ADDENDUM NO. 1
TO
CITY OF AUBURN, MAINE
2018 RECONSTRUCTION PROJECT
March 2, 2018

The following changes have been made to the Bid Documents:

New Auburn Village Center
Redevelopment - Phase 1
LAYOUT & GRADING PLAN

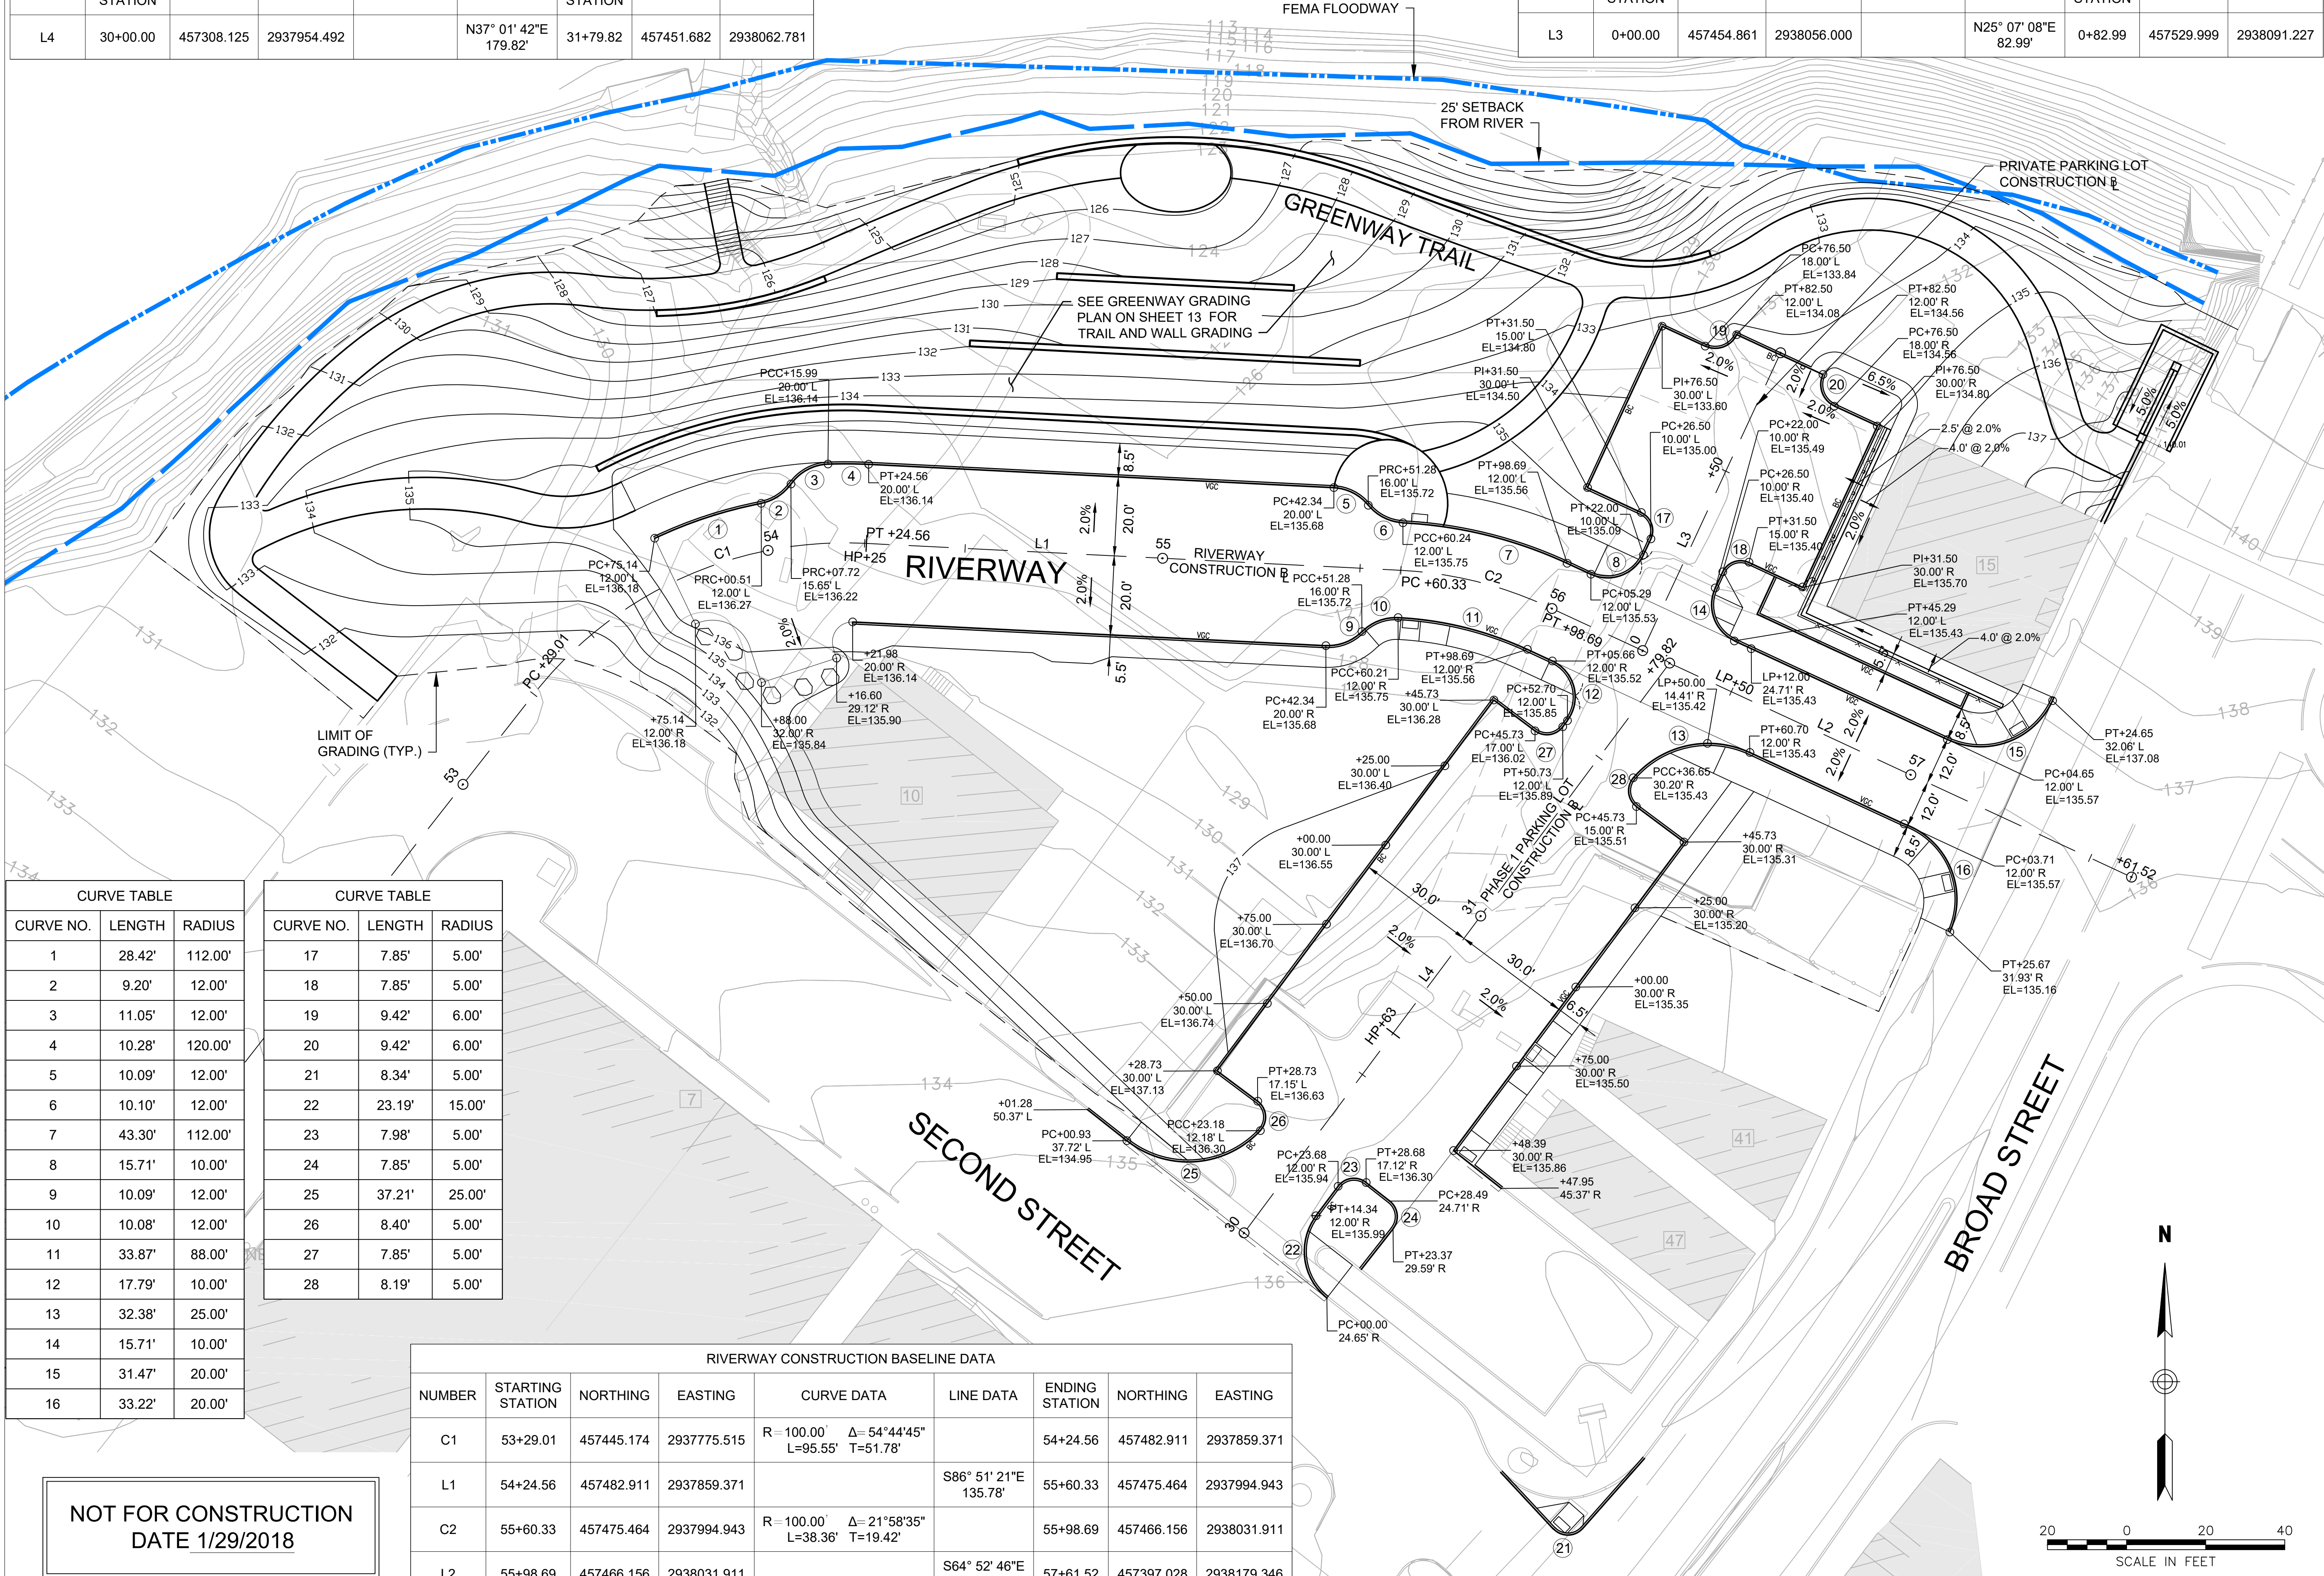
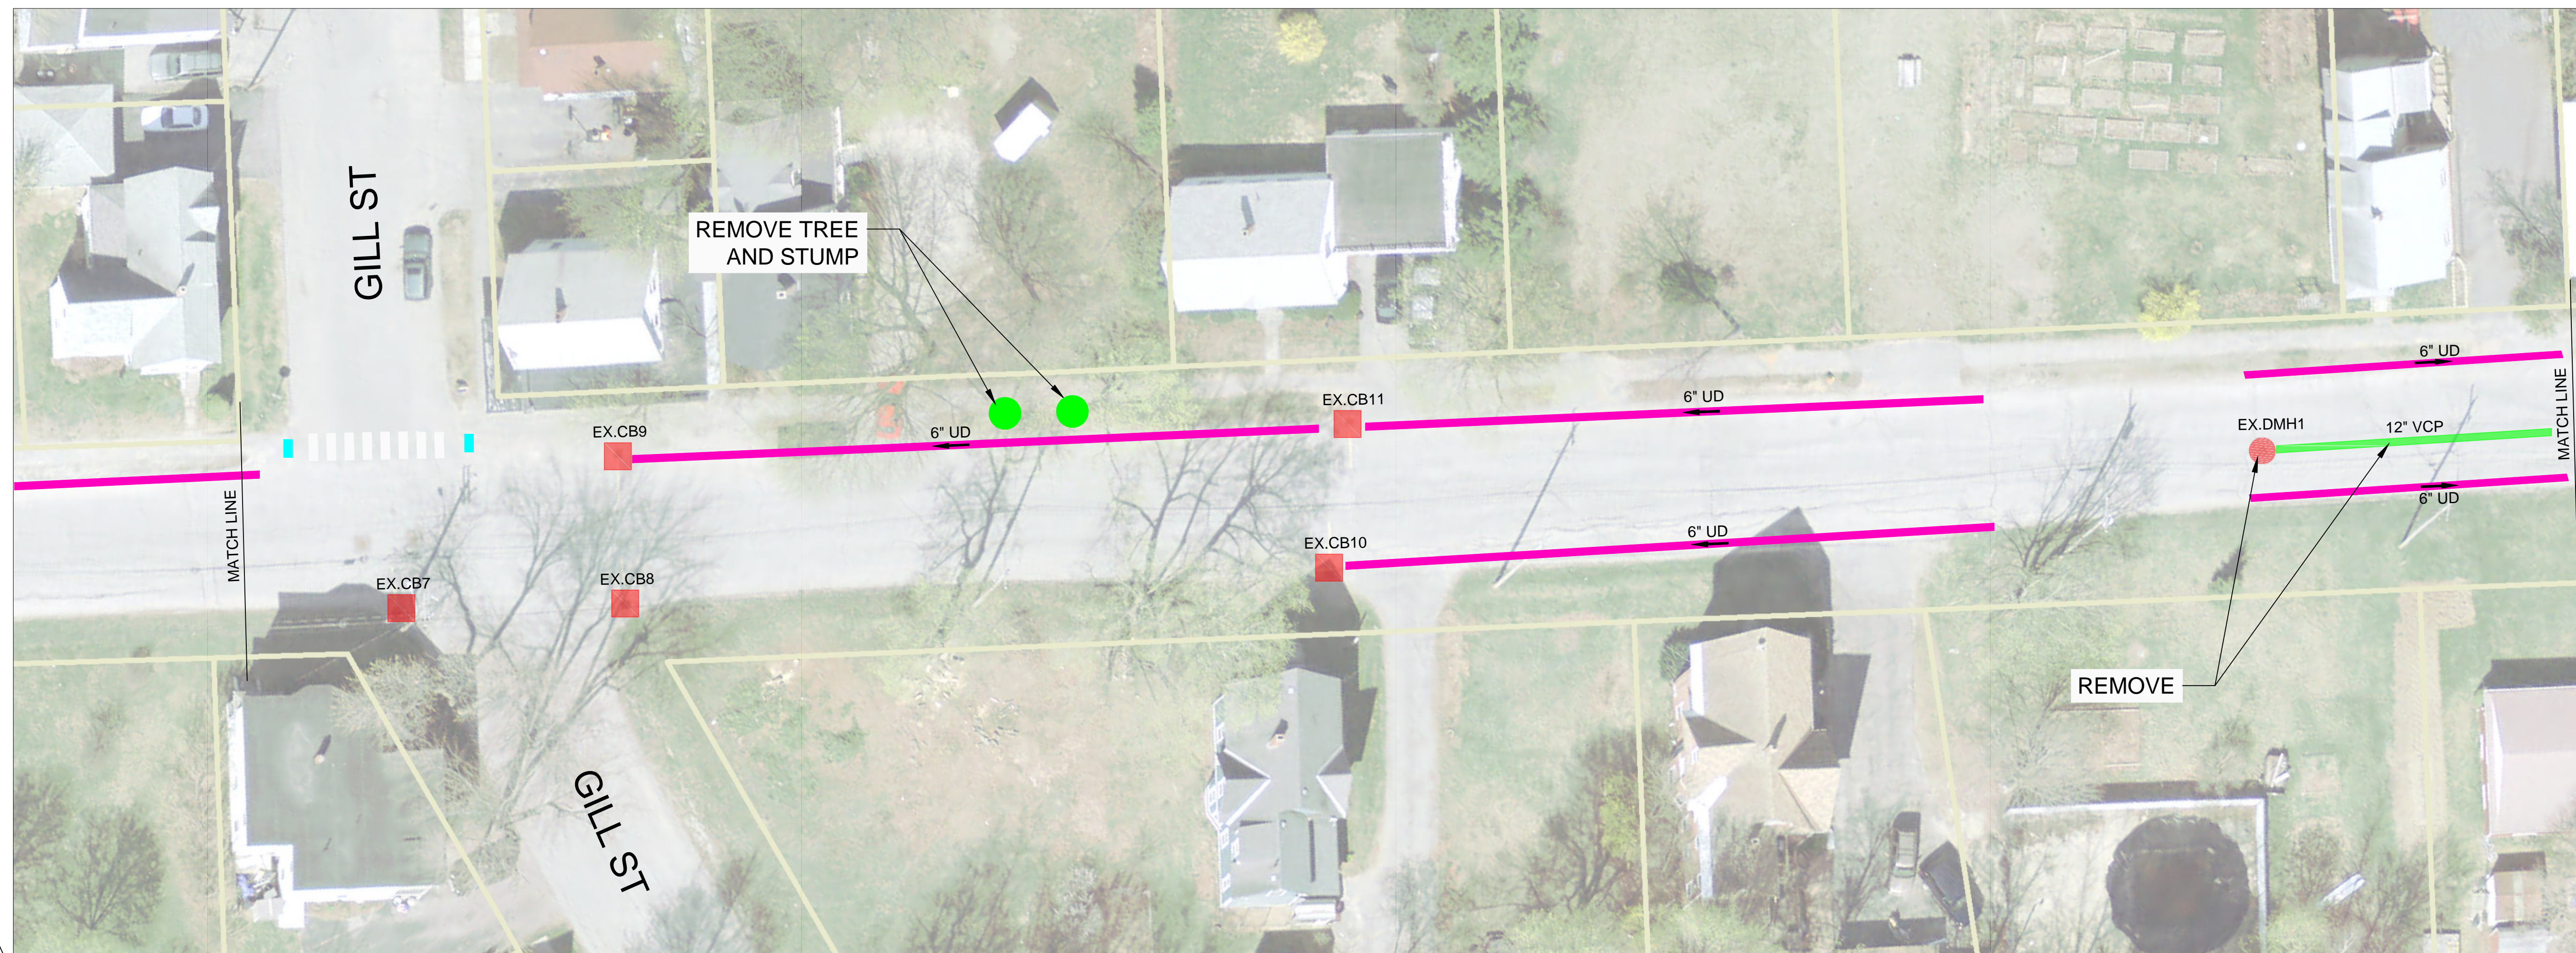
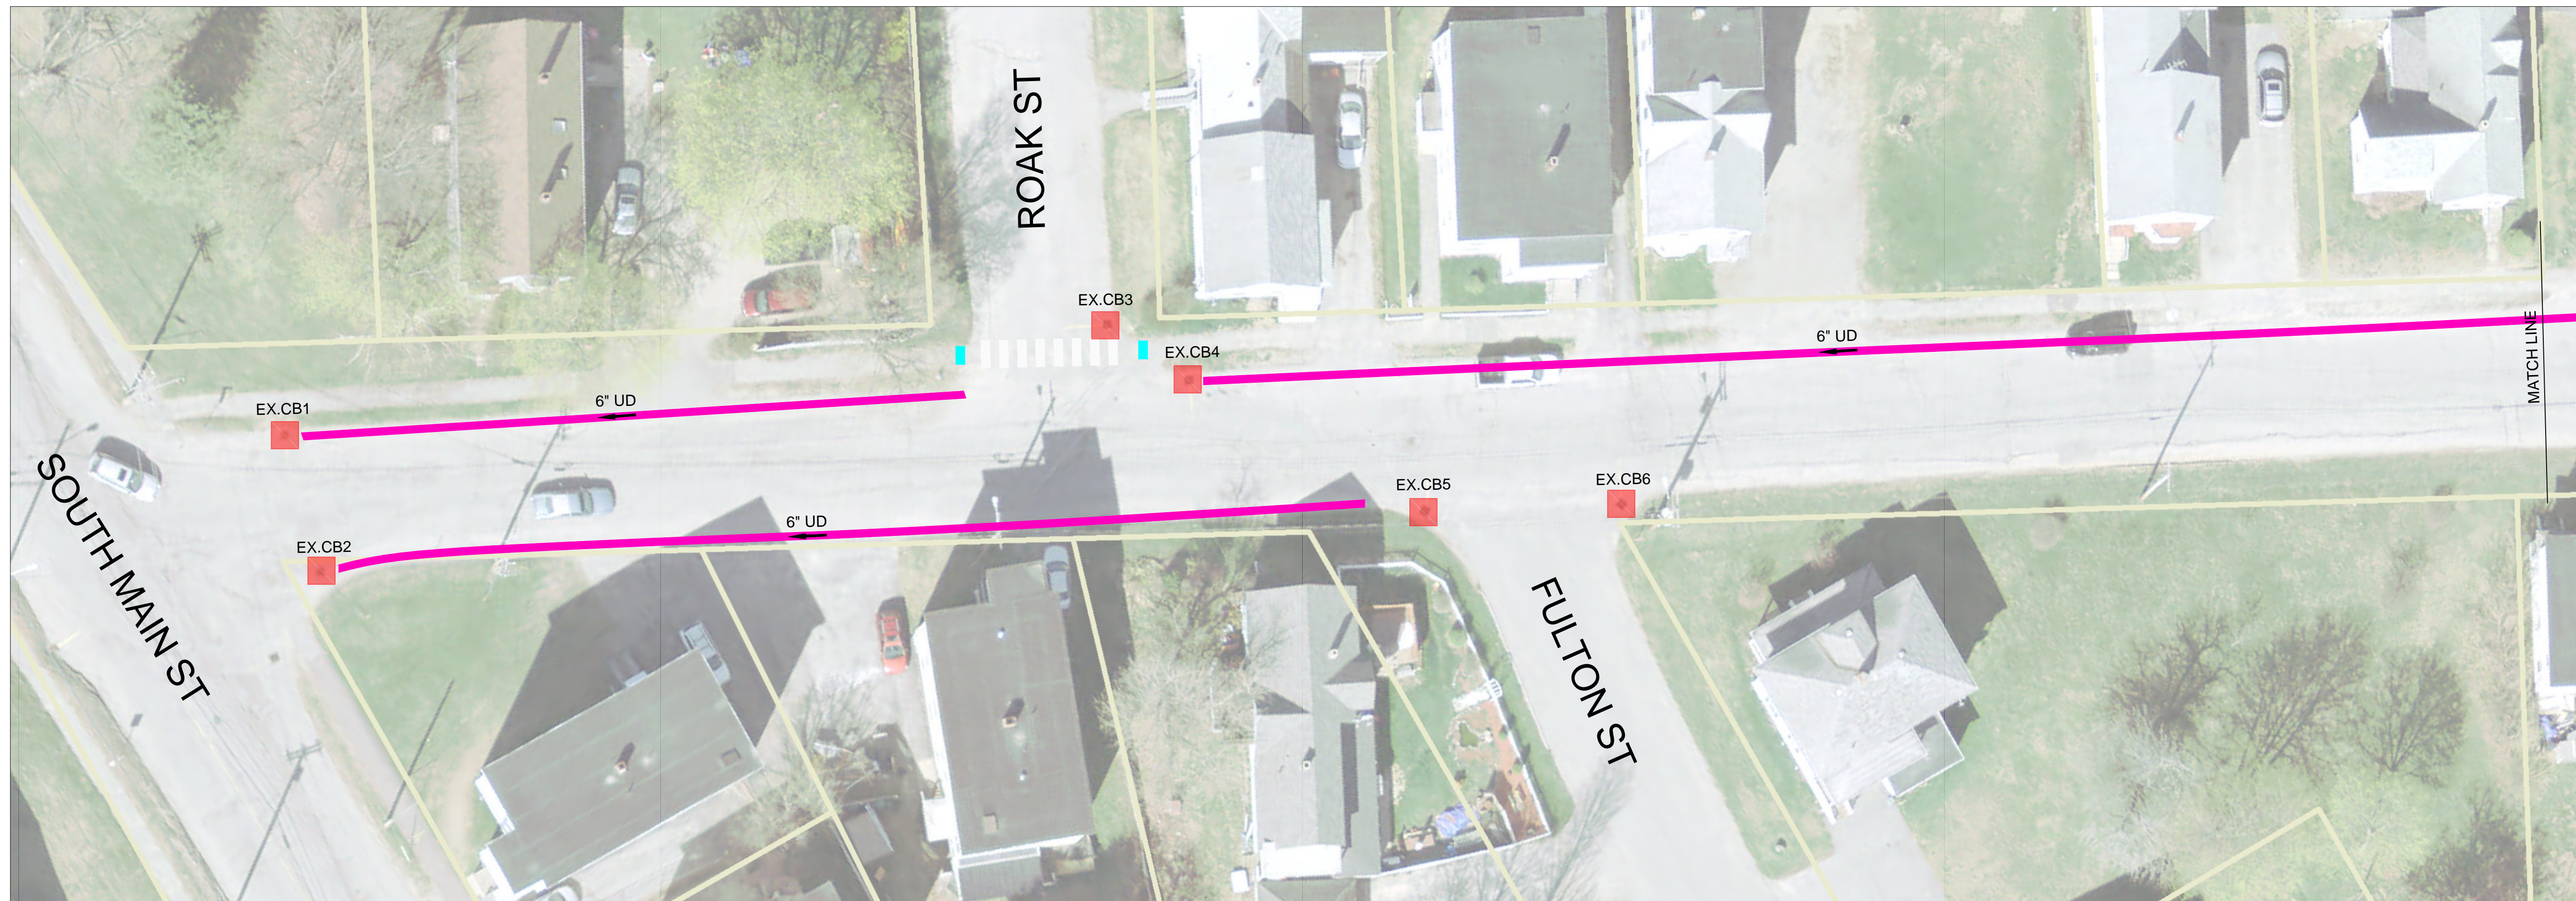
Grading plan of the Second Street Site attached.

Question: Will all the excavated material fit into the Second Street Site?

Answer: The Second Street Site is estimated to handle 10,000 cubic yards and should take on the fill proposed in this project.

Question: Will there be additional fill material hauled to the Second Street Site that the Contractor will need to manage?

Answer: AWS D may add some fill, however the quantity will be negligible.

Question: Will there be any quality assurance on the compaction of the Second Street Site fill material?

Answer: Quality assurance material testing is not anticipated for the fill for the Second Street Site. Compaction efforts will be monitored by the Project Engineer. A compaction method plan (i.e. lift thickness and number of passes) will be established based on equipment size and fill material.
